Revised urban design plans and memorandum

Ref: 2023_084 Greene Mt Iron Junction Minute 7 Response_A

**MT IRON JUNCTION FAST TRACK – SECTION 67 REQUEST FOR FURTHER
INFORMATION – RFI RESPONSE**

MT IRON JUNCTION, WĀNAKA, 9382 (LOT 6 DP 605028, LOT 2 DP 60502, LOT 3 DP 359869)

client / project name: MT IRON JUNCTION, WĀNAKA
drawing name: **SECTION 1.1 - 35 OLD RACECOURSE ROAD**
designed by: ANCA BELU
drawn by: ANCA BELU
original issue date: 13 AUGUST 2026
scale: As shown

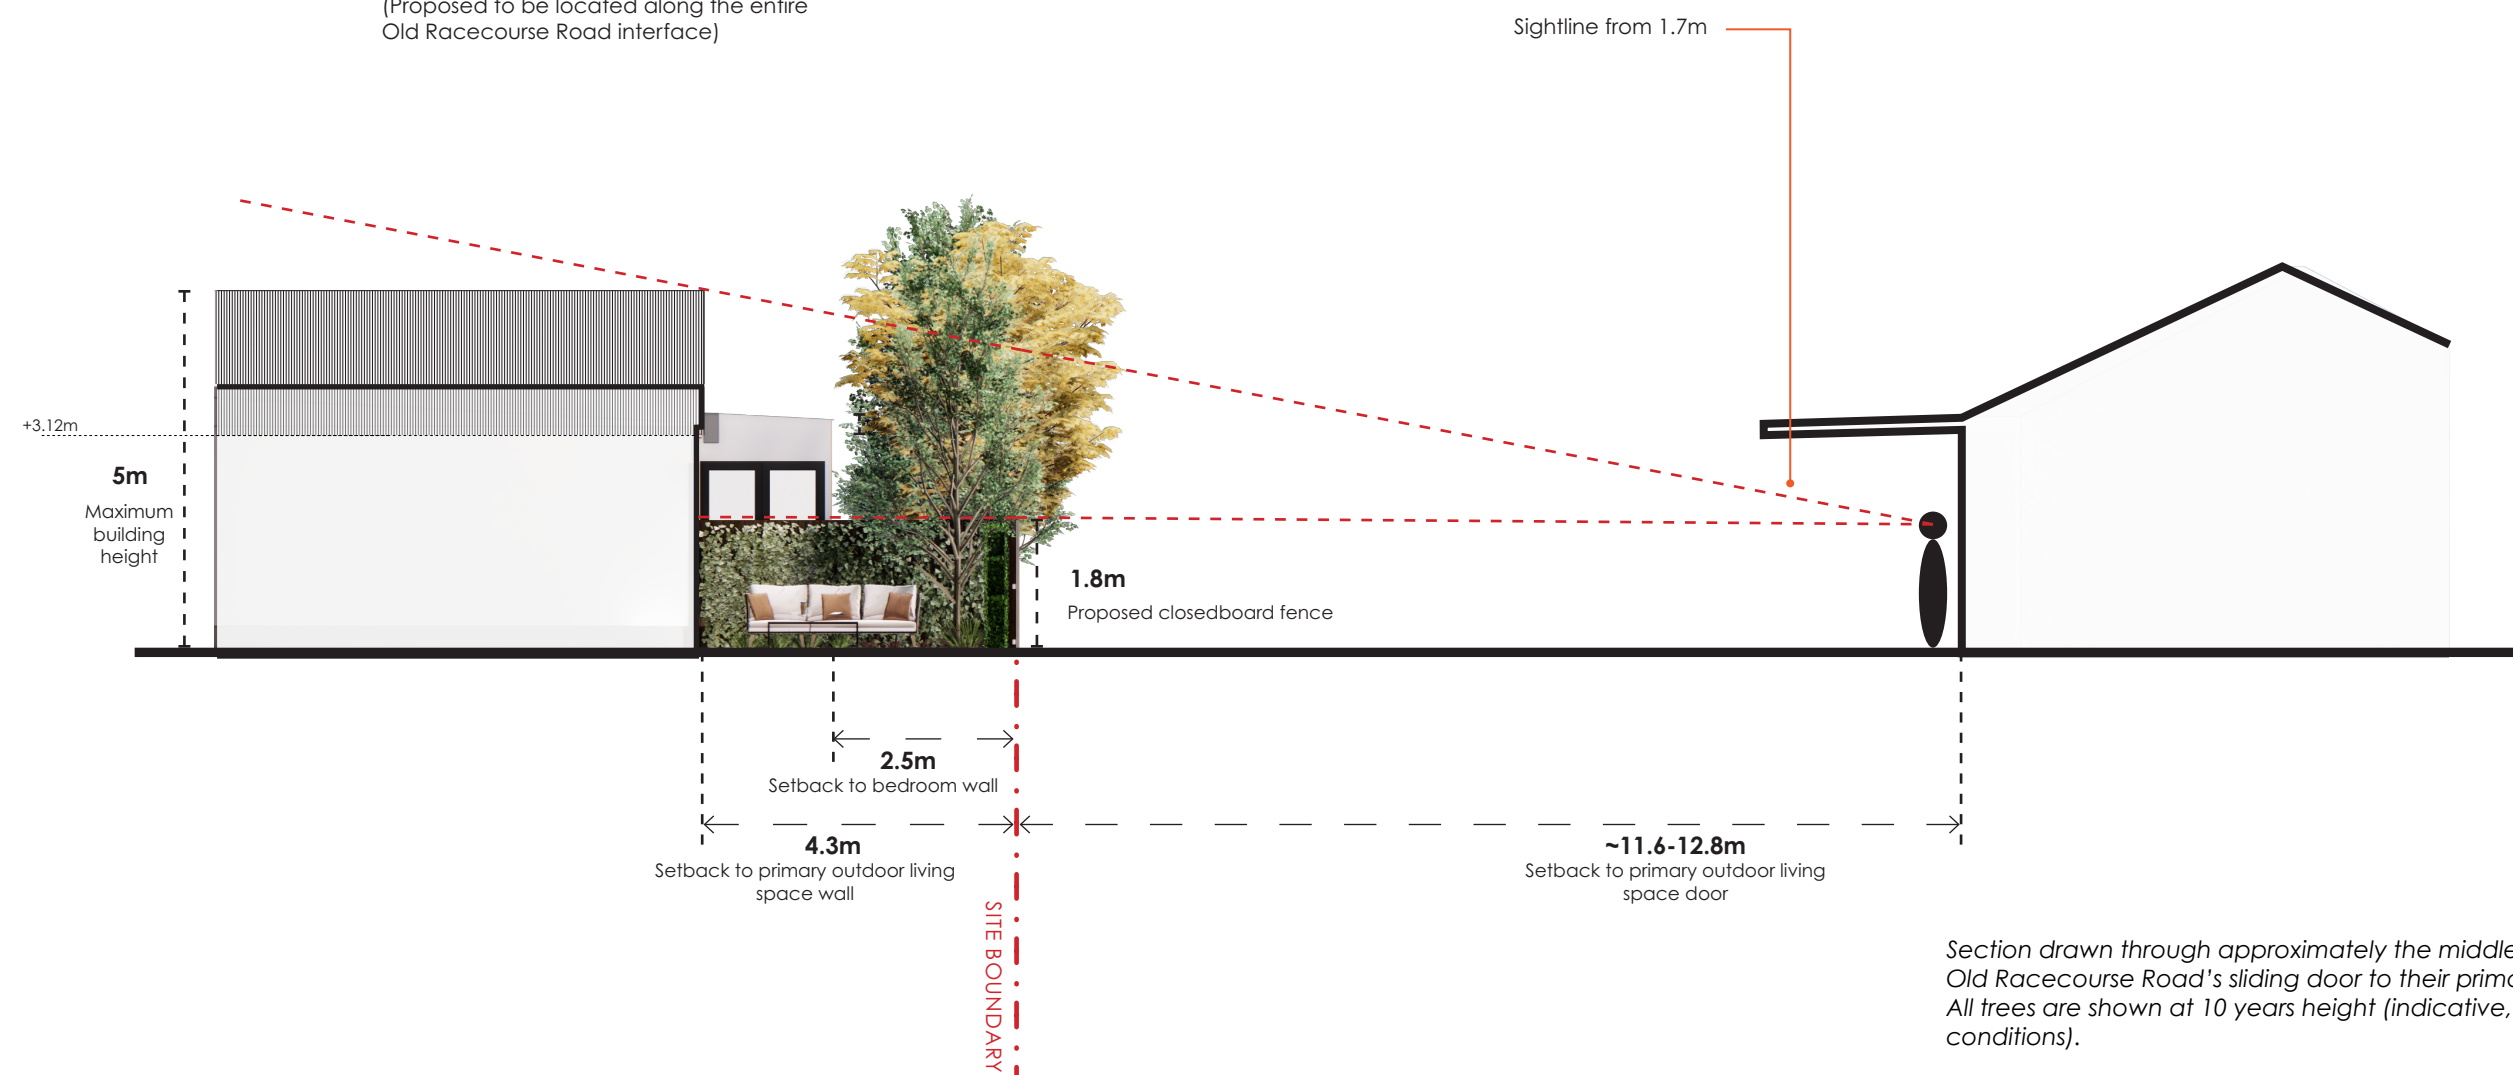
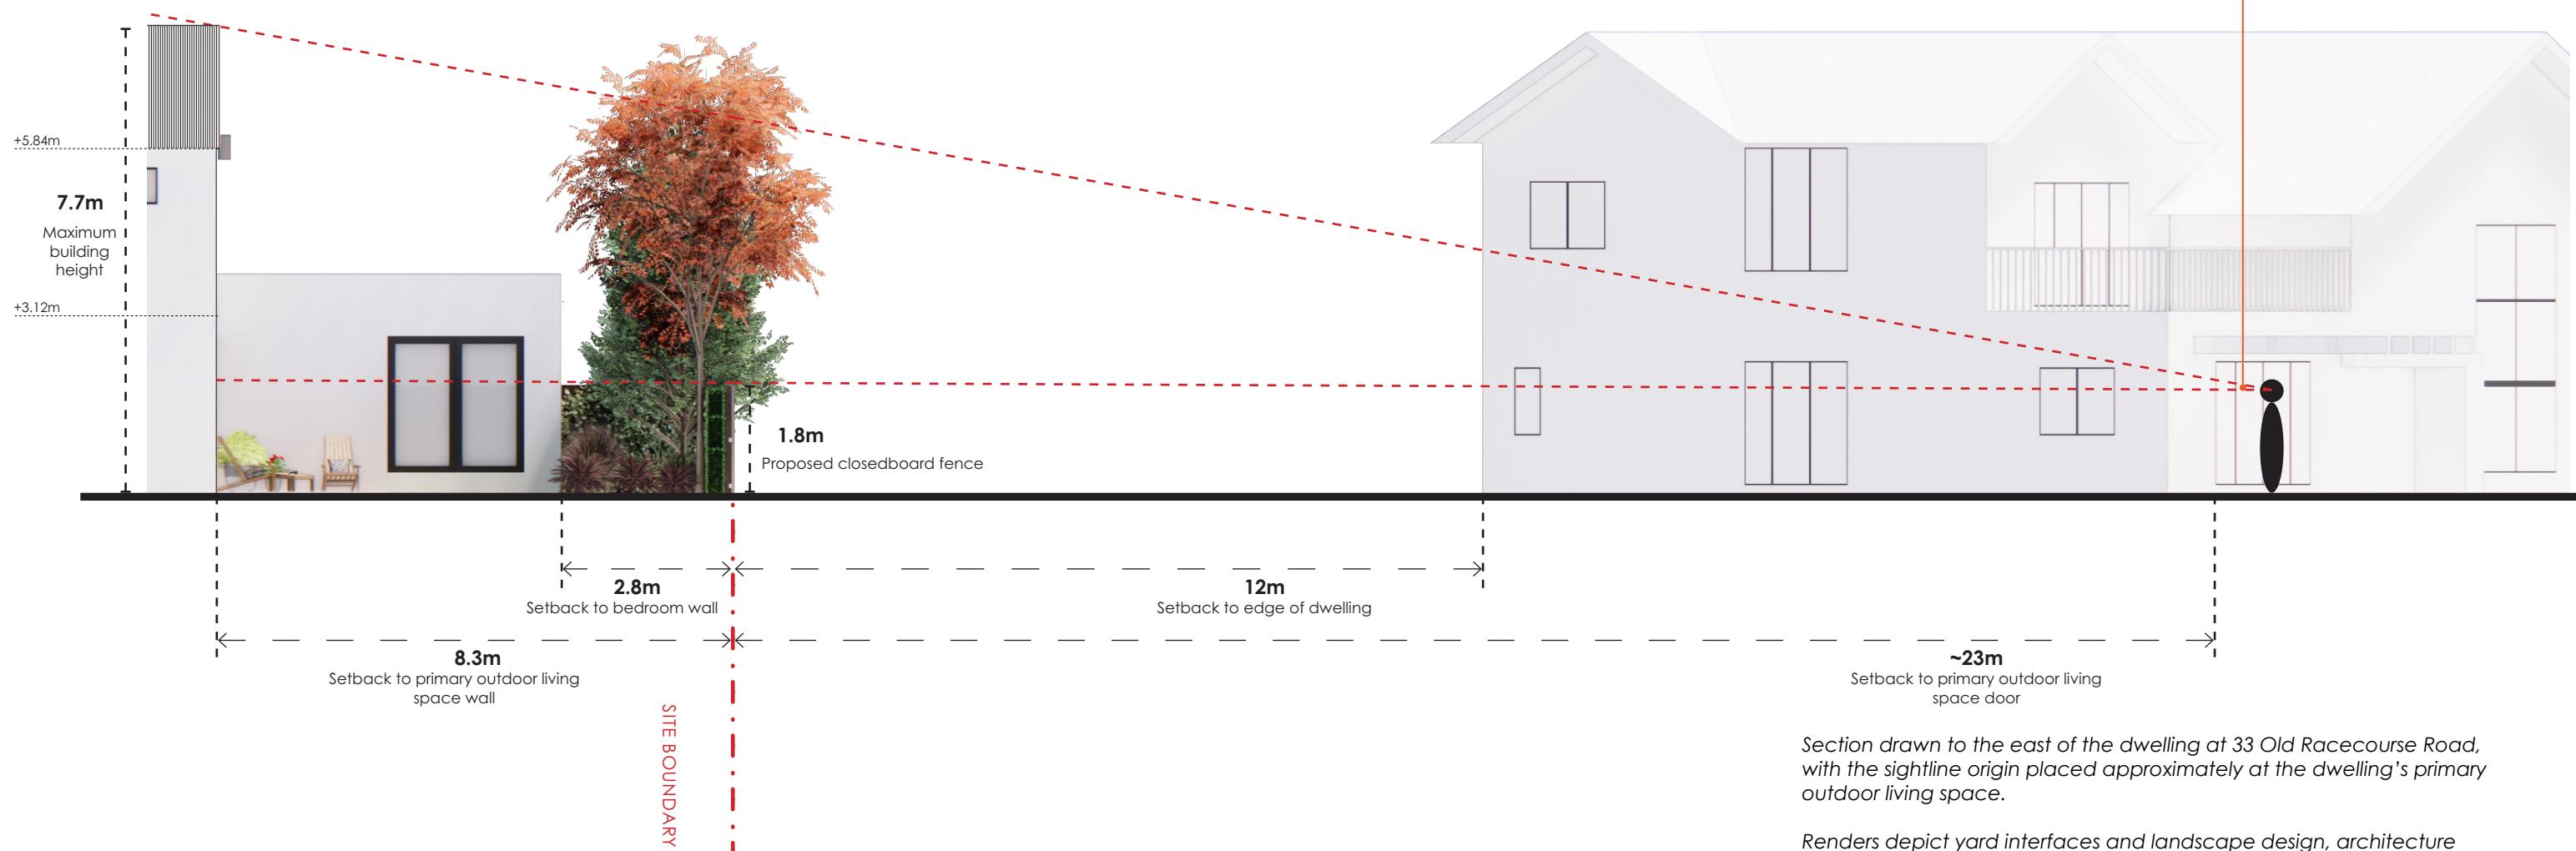
The remaining 12 Typology B dwellings along the Old Racecourse Road boundary have been replaced with Typology A dwellings. As a result, all dwellings adjoining this boundary are now Typology A and the built form along the full length of the interface is single-storey (refer to DCM S67 Graphic Attachment revision B, dated 13/08/2026).

Updated interface sections have been prepared to show the previous and revised conditions along the Old Racecourse Road boundary (refer to DCM Minute 7 Graphic Attachment). The drawings compare the previously proposed two-storey Typology B units with the revised single-storey Typology A units and show the resulting change in the amount of built form visible from the neighbouring properties. They also show the relationship

client / project name: MT IRON JUNCTION, WĀNAKA
drawing name: **SECTION 2.1 - 33 OLD RACECOURSE ROAD**
designed by: ANCA BELU
drawn by: ANCA BELU
original issue date: 13 AUGUST 2026
scale: As shown

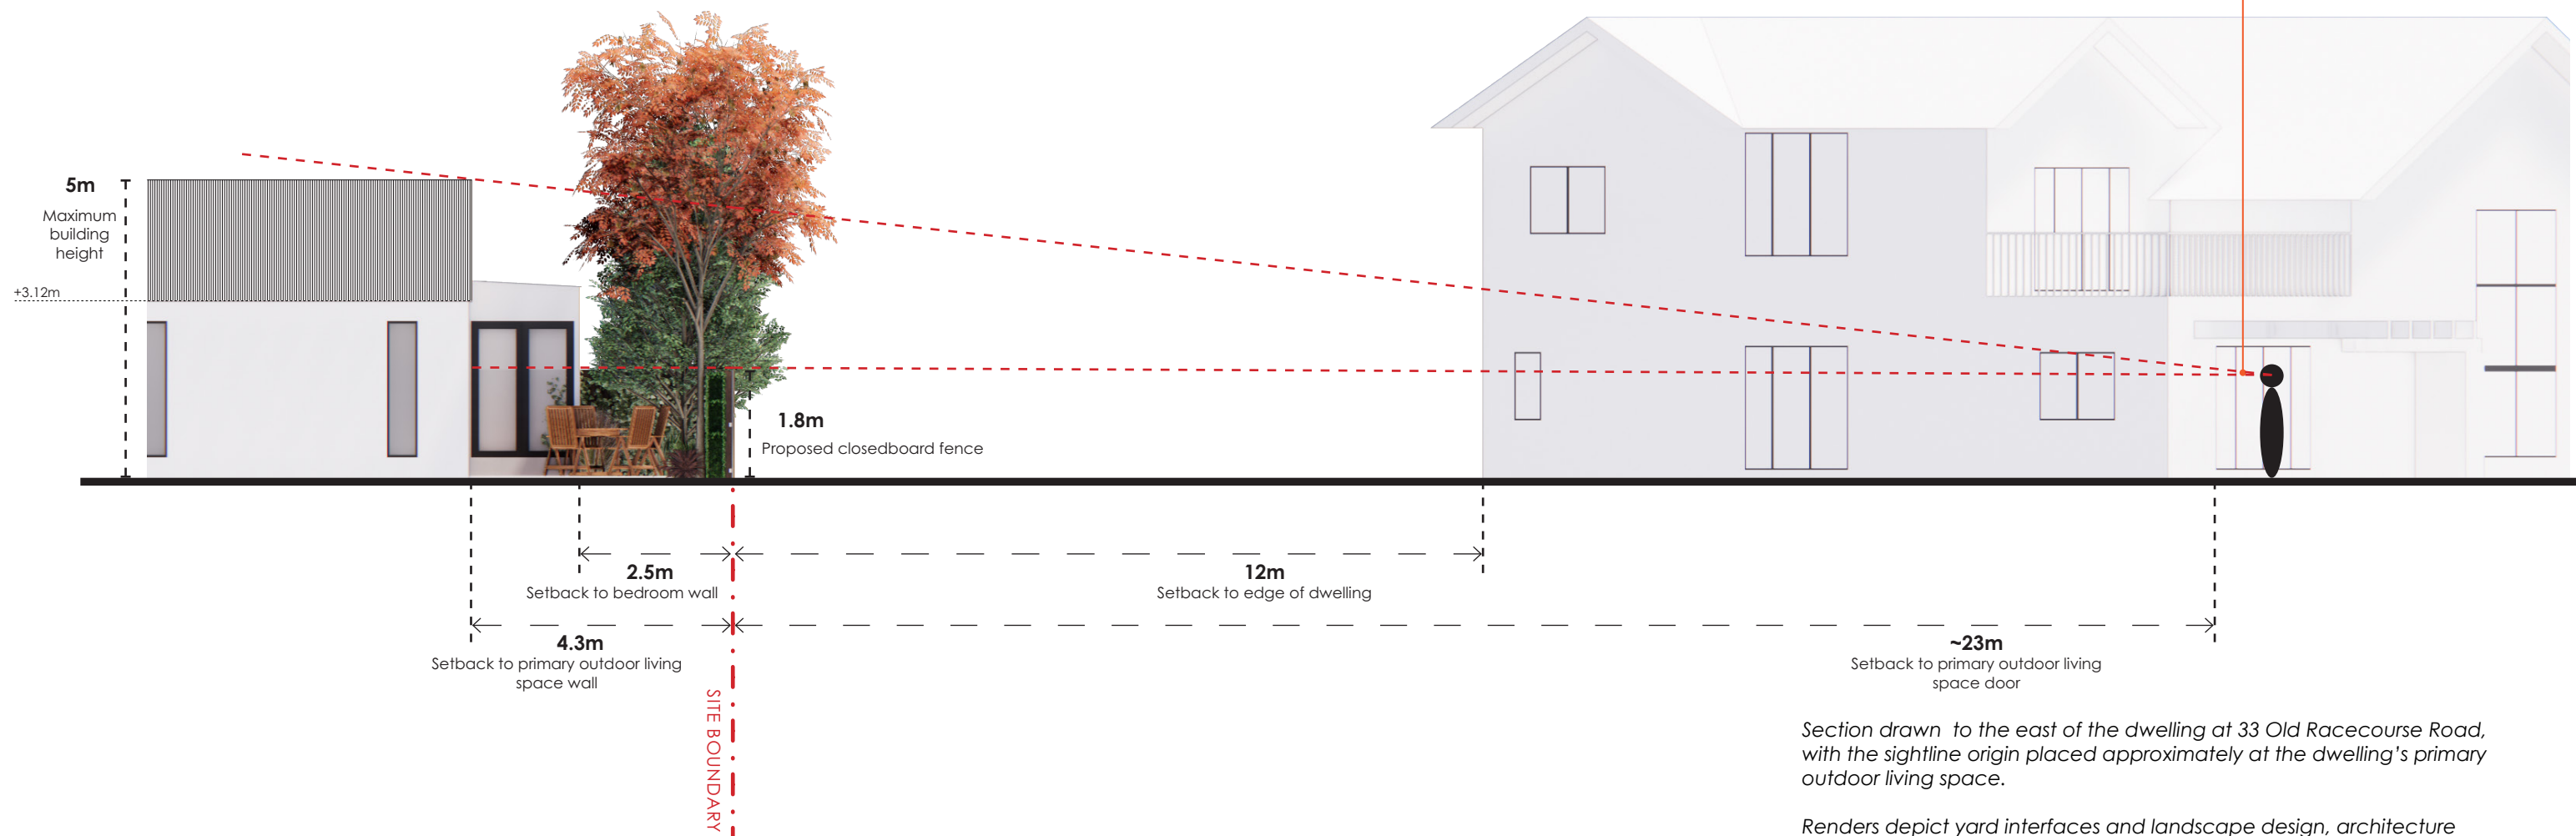
(Removed along Old Racecourse Road interface, to be replaced with Typology A, refer sheet 005)
